Figure 2.12i
Infrastructure Design Review
- Turbine 09

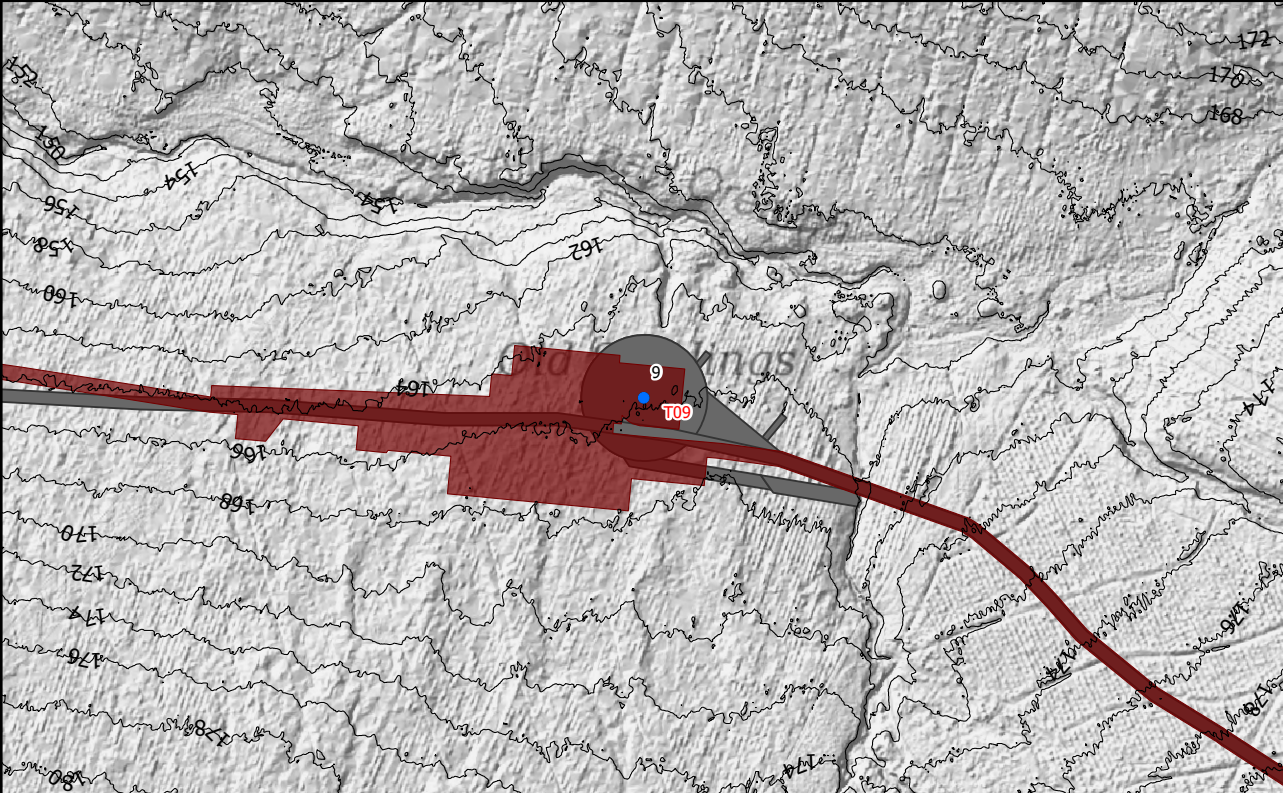
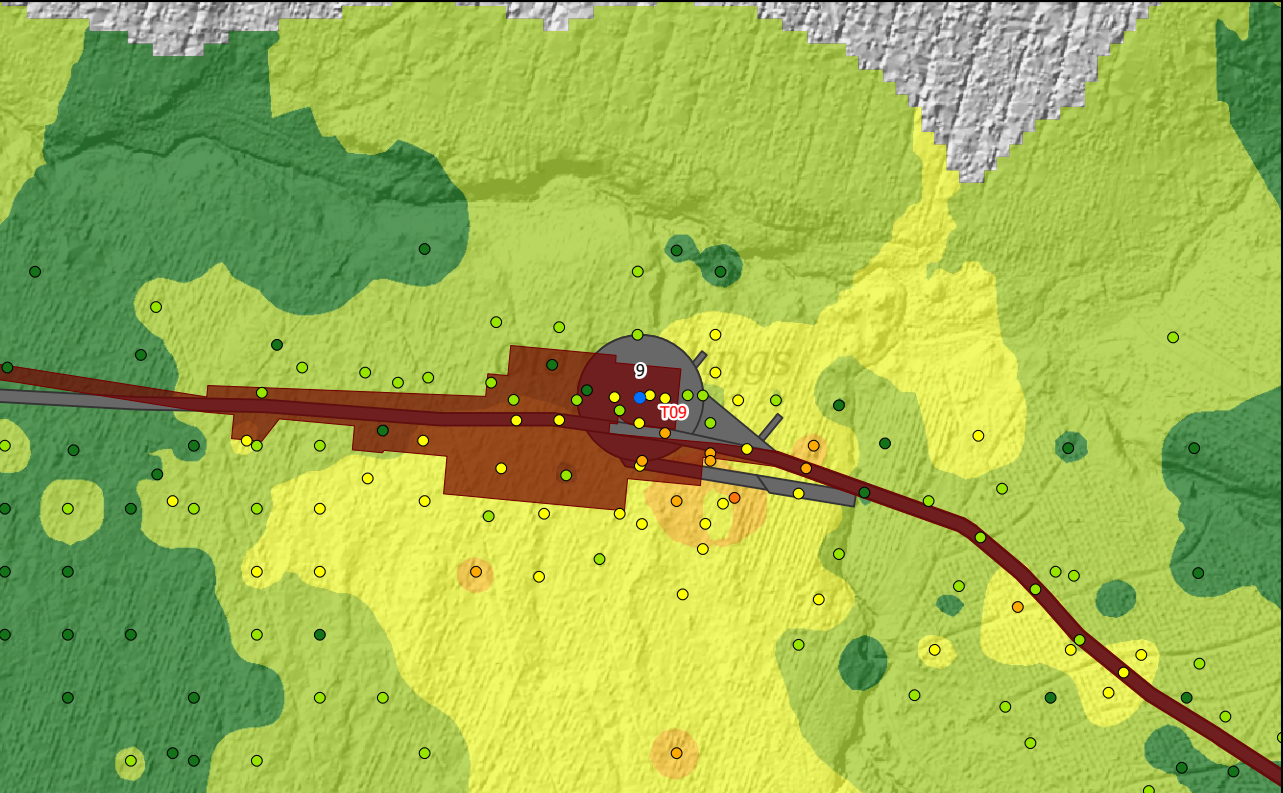
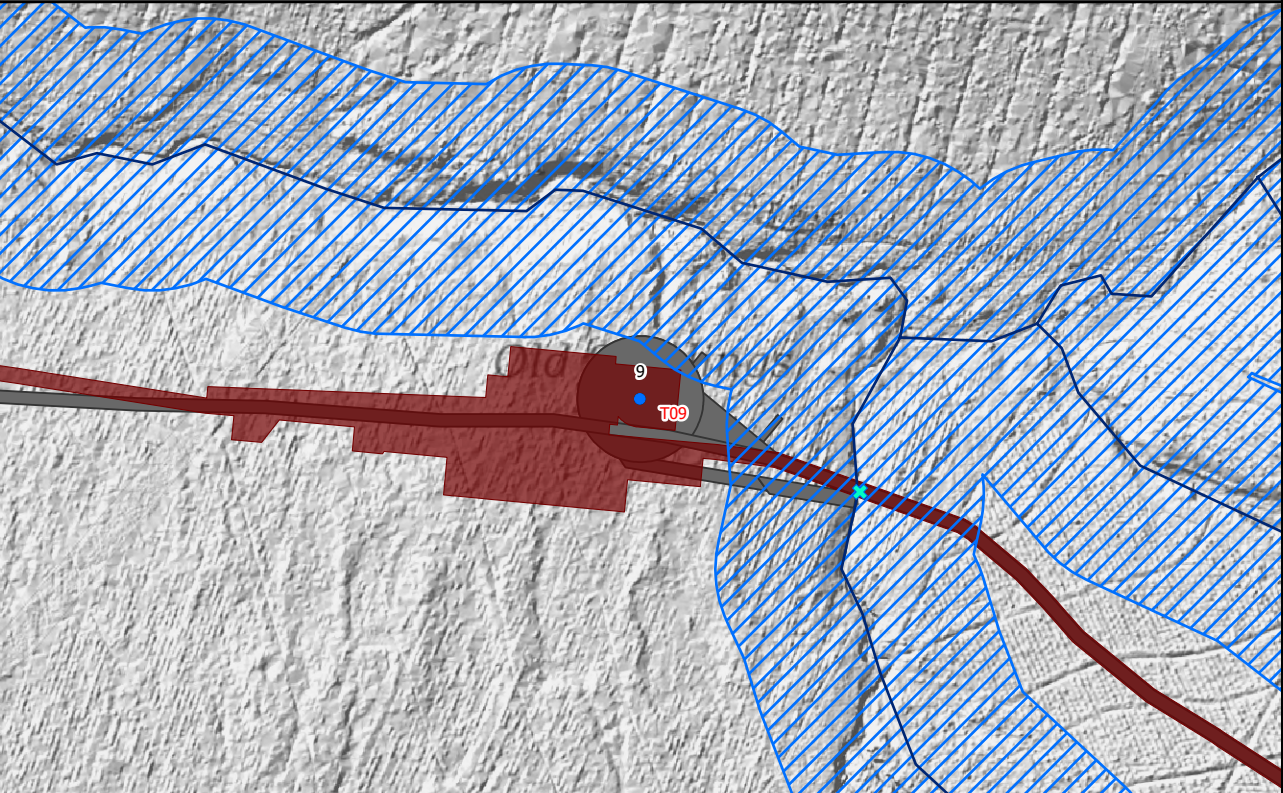
T09: Reason for Moving: This turbine location has not moved from the current consented location.

Engineering: The hardstand has been rotated 180 degrees to allow for components to be delivered to the location without the need to turn the delivery vehicle around before offloading. The plan for turbine deliveries is to drive directly onto the hardstand and offload components. The unloaded vehicles will then use a the next junction or loaded turning head at T11 to turn and exit the site.

Geology Impacts: The infrastructure has been rotated which has the benefit of avoiding more of the pockets of deeper peat than the consented layout sits within. The position has been pushed as far away from the peat as possible without impacting water course buffer to the North.

Ecology Impacts: The turbine and infrastructure is located in an area of commercial coniferous forest that will be clear felled as part of the project scope.

Hydrology Impacts: The turbine infrastructure has been moved outside of a 50m water course buffer to the North and East. Any micrositing during construction would be limited in this direction to ensure that this buffer is maintained.
